Office Action Summary

10/576,580

DETAILED ACTION

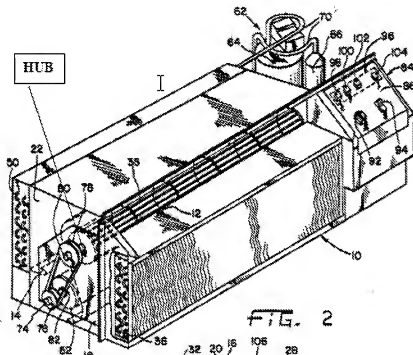
Regarding claims 6 and 20, Wollaber teaches that the indoor and outdoor cross flow fans comprise: a hub (annotated below) arranged extending in a longitudinal direction of the at least one indoor heat exchanger (illustrated below) and connected to a driving motor (72); and a plurality of blades (annotated below) provided on an outer circumferential surface of the hub

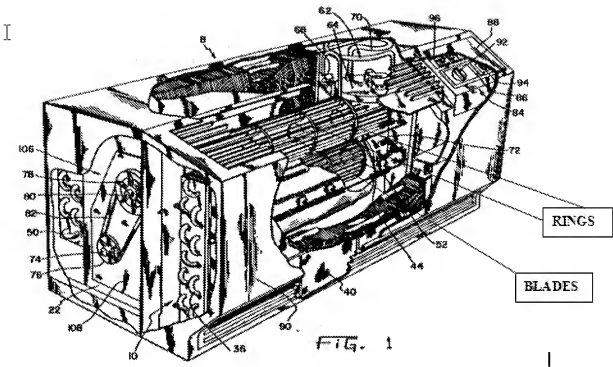
with a certain interval therebetween (illustrated below) and arranged extending in the longitudinal direction of the at least one indoor heat exchanger (illustrated below).
